DART SERVICE INSTRUCTION

TO AMEND INSTALLATION INSTRUCTIONS IIN-D117-762 REV. E AND
INSTRUCTIONS FOR CONTINUED AIRWORTHINESS ICA-D117-762 REV. 4

REF FAA STC: SR01853SE

FIGURE 1 - GHL UPGRADE INSTALLATION

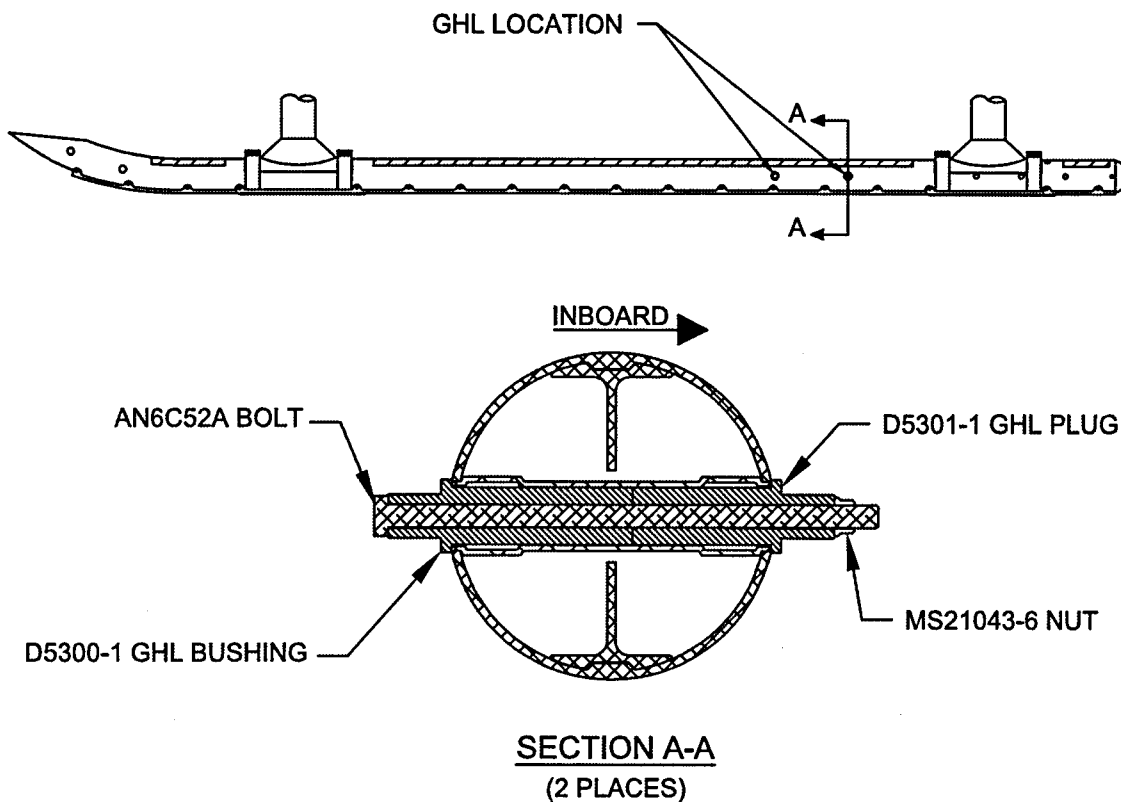
The purpose of this Dart Service Instruction (DSI) is to replace the ground handling lugs (D3864-1 Bushings, AN6C51A Bolts and MS21043-6 Nuts) on the D117-762-XXX Skidtubes with a structurally superior lug design (D5300-1 Bushings, D5301-1 Plugs, AN6C52A Bolts, MS21043-6 Nuts) as shown in Figure 1. The new hardware will be included in D117-762-011 @ CHG 004 and subsequent.

- 2.1 Loosely install (qty 2) D5300-1 GHL Bushing & (qty 2) D5301-1 GHL Plug wet with Proseal 890 or MIL-S-8802 Class B2 Sealant in location shown in Figure 1.
- 2.2 Install (qty 2) AN6C52A Bolts and (qty 2) MS21043-6 Nuts in accordance with Figure 1. Clean up squeezed out Proseal and apply fillet seal around D5300-1 & D5301-1.
- 2.3 Torque AN6C52A Bolts 160 - 190 in-lbs (18.1 - 21.5 N-m).
